Exhibit G

PROJECT  
412 Richardson PL  
412 Richardson Place, NW  
Washington, DC

DRAWING TITLE  
CELLAR AND FIRST  
LEVEL PLAN -  
PROPOSED

A101  
Board of Zoning Adjustment  
District of Columbia  
CASE NO. 19441  
ENR 101-10-2016

DRAWING TITLE  
SECOND AND THIRD  
LEVEL PLAN -  
PROPOSED

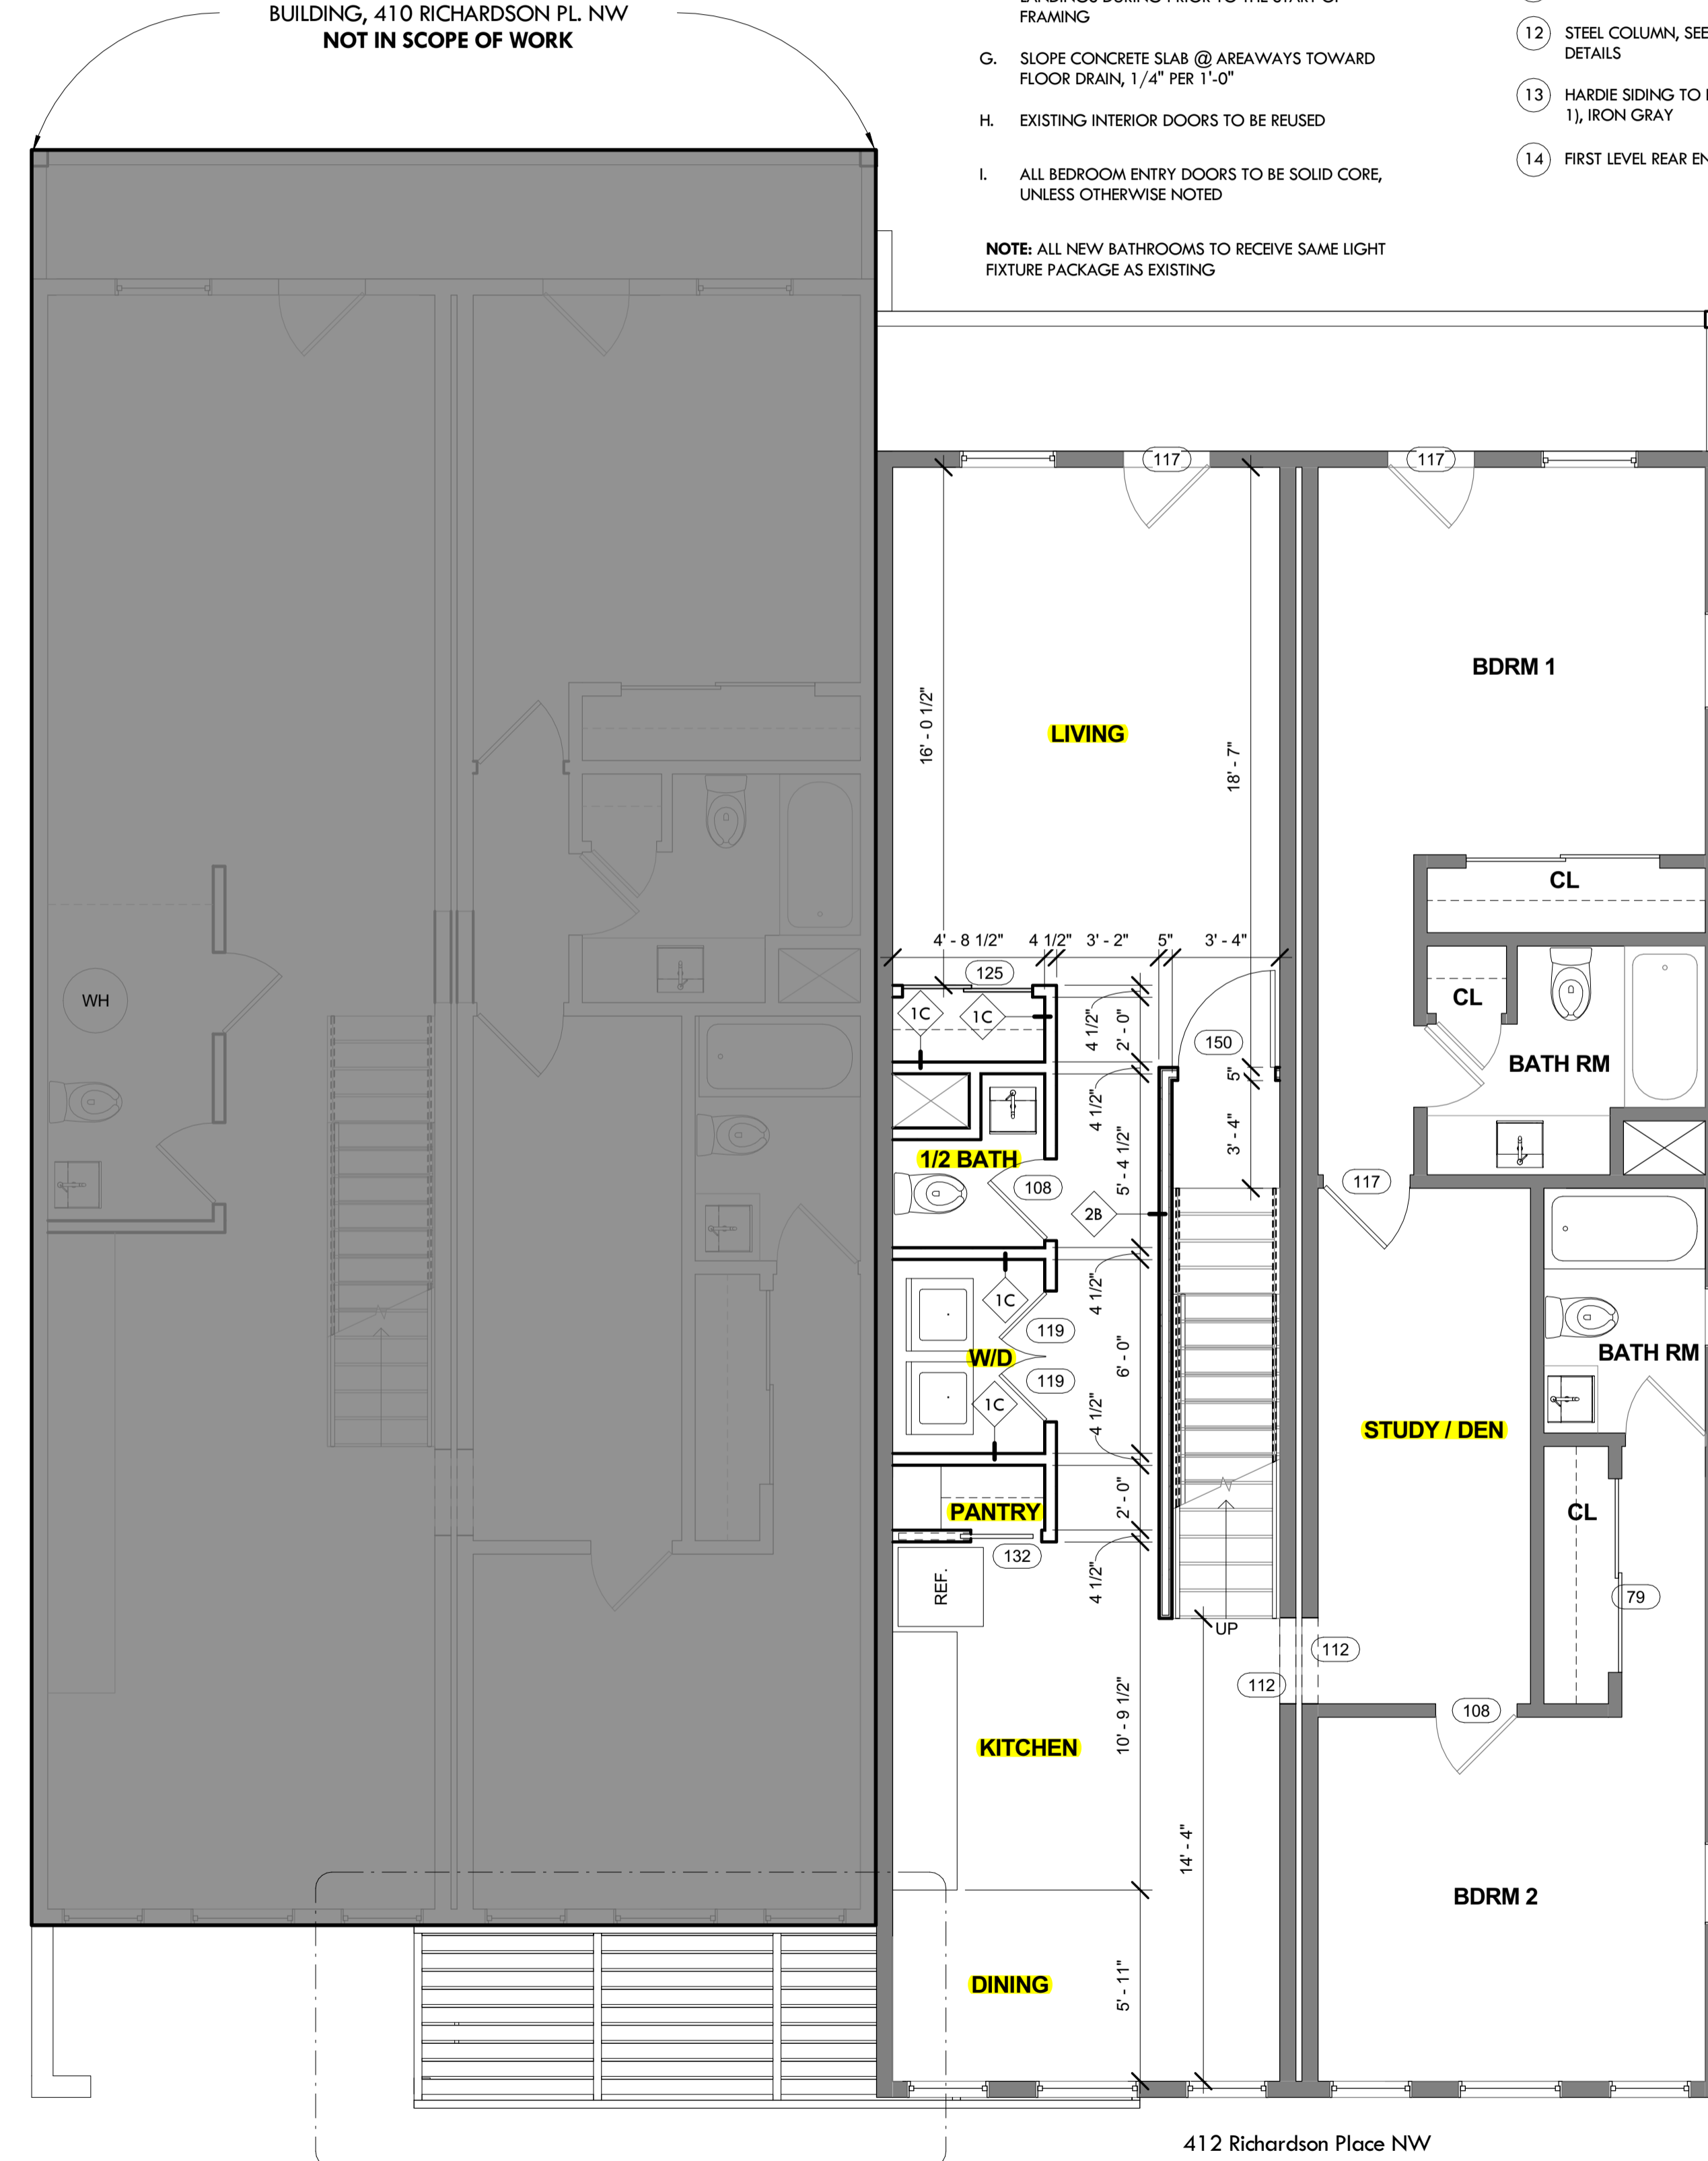
**906.2 General requirements.** Portable fire Extinguishers shall be selected, installed and maintained in accordance with this section and NFPA 10.

**906.3.1 Class A fire hazards.** Portable fire extinguishers for occupancies that involve primarily Class A fire hazards, the minimum sizes and distribution shall comply with Table 906.3(1).

**906.9.1 Extinguishers weighing 40 pounds or less.** Portable fire extinguishers having a gross weight not exceeding 40 pounds (18 kg) shall be installed so that their tops are not more than 5 feet (1524 mm) above the floor.

**906.2 General requirements.** Portable fire Extinguishers shall be selected, installed and maintained in accordance with this section and NFPA 10.

**906.3.1 Class A fire hazards.** Portable fire extinguishers for occupancies that involve primarily Class A fire hazards, the minimum sizes and distribution shall comply with Table 906.3(1).

**906.9.1 Extinguishers weighing 40 pounds or less.** Portable fire extinguishers having a gross weight not exceeding 40 pounds (18 kg) shall be installed so that their tops are not more than 5 feet (1524 mm) above the floor.
